CHRYSLER A604 (41TE) UPDATE HANDBOOK

**AUTOMATIC TRANSMISSION SERVICE GROUP
9200 S. DADELAND BLVD. SUITE 720
MIAMI, FLORIDA 33156
(305) 670-4161**

"UPDATE HANDBOOK"

Figure 66

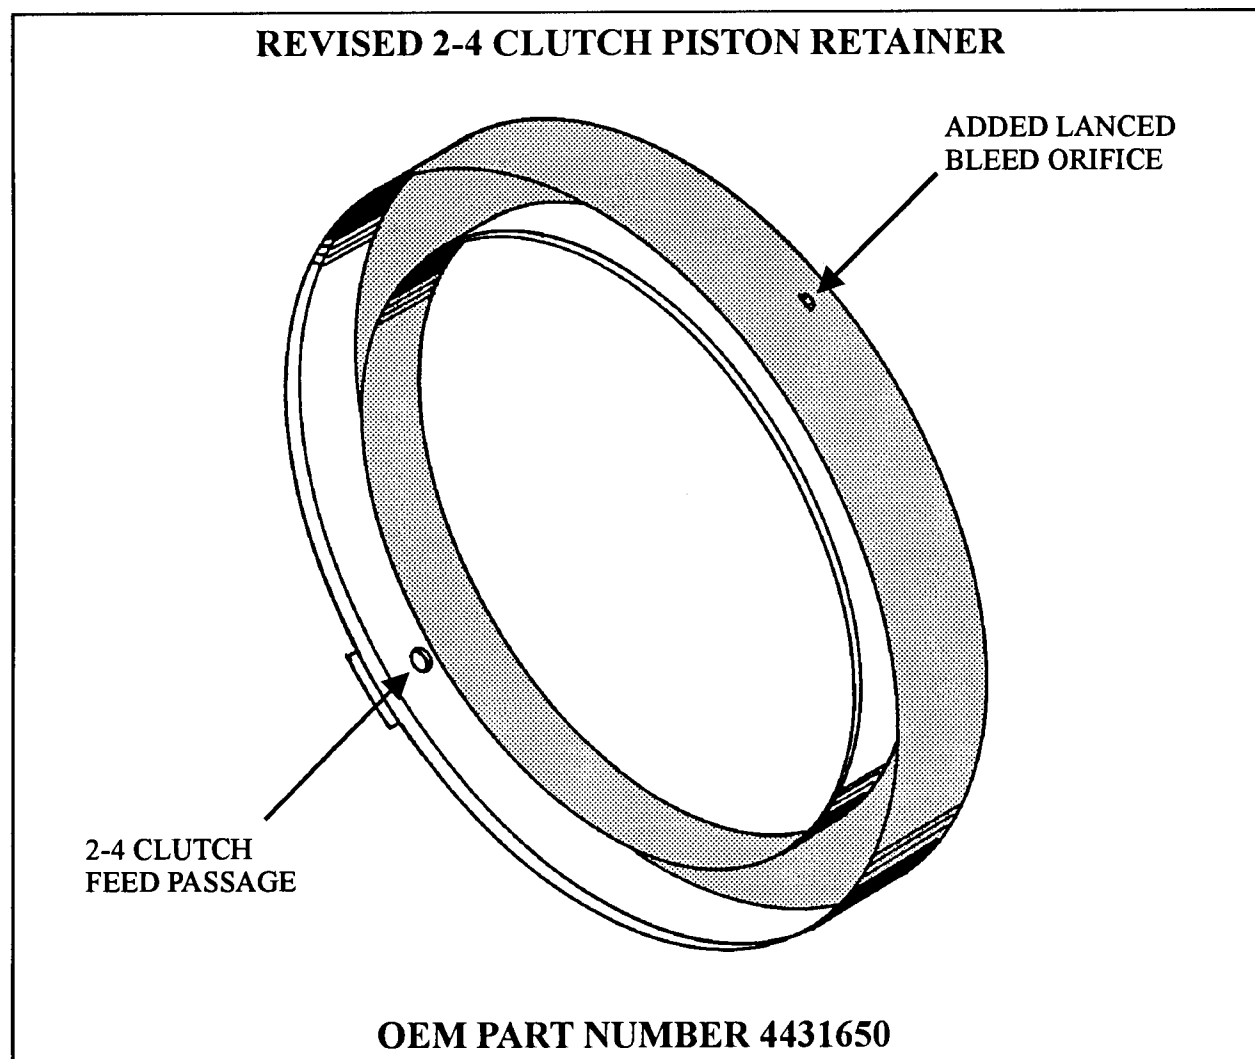
CHANGE: Beginning at the start of production for the 1995 model year, all Chrysler A604 (41TE) and A606 (42LE) transaxles were produced using a revised 2-4 Clutch Piston Retainer with an added lanced bleed orifice (See Figure 66).

- (1) 2-4 CLUTCH PISTON RETAINER - Lanced bleed orifice added to the retainer in the location shown in Figure 66.

The revised 2-4 Clutch Piston Retainer with the added lanced bleed orifice will back service ALL previous models of Chrysler A606 (41TE) and A606 (42LE) transaxles. There was not a part number change, so the revised retainer is available under OEM part number 4431650.

Figure 73

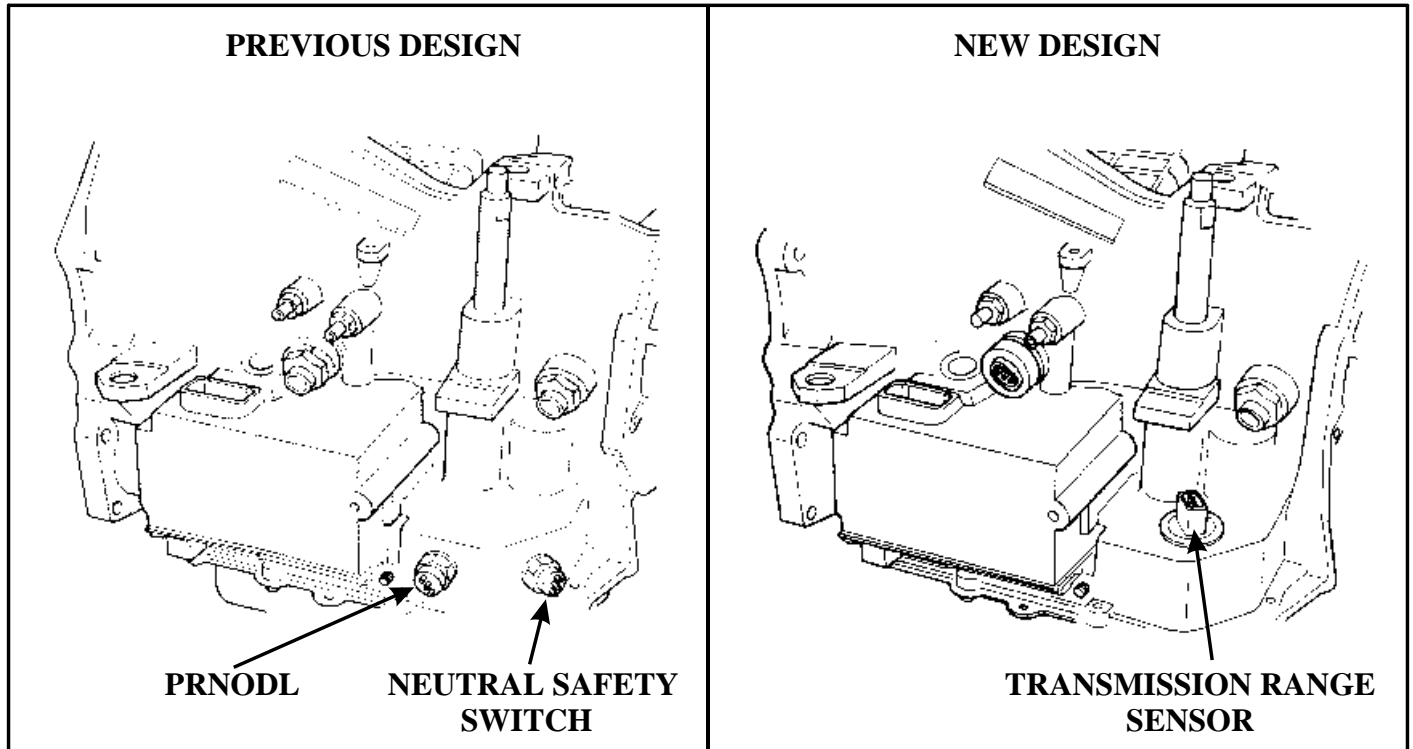
CHANGE: Beginning at the start of production 1996, some models equipped with the 41TE (A604) transaxle replaced the PRNODL and Neutral Safety Switch with a Transmission Range Sensor as seen in Figure 73.

- (1) PRNODL SWITCH - The previously used Park, Reverse, Neutral, Overdrive, Drive, Low Switch (PRNODL) has been eliminated and replaced with the new Transmission Range Sensor (See Figure 73).

- (2) NEUTRAL SWITCH - The previously used Neutral Switch has been eliminated and replaced with the new Transmission Range Sensor (See Figure 73).
- (3) TRANSAXLE CASE - The casting of the case change with the elimination of the two threaded holes for the PRNODL and Neutral Safety Switch. An access hole has been added to accommodate the new TRS sensor connector as the switch which is mounted on the valve body (See Figure 73).

Figure 74

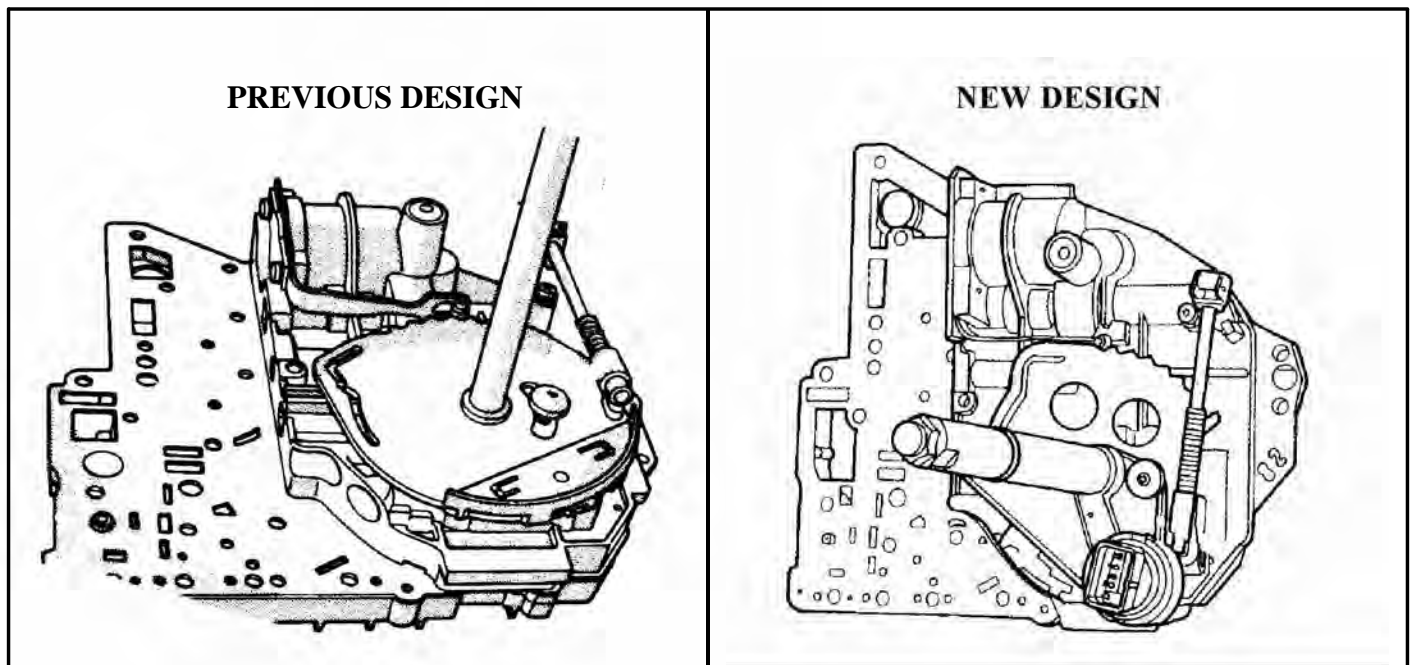
- (4) VALVE BODY - The manual arm shaft and rooster comb assembly and the valve body changed in design to accommodate the mounting of the new TRS sensor (See Figure 74).
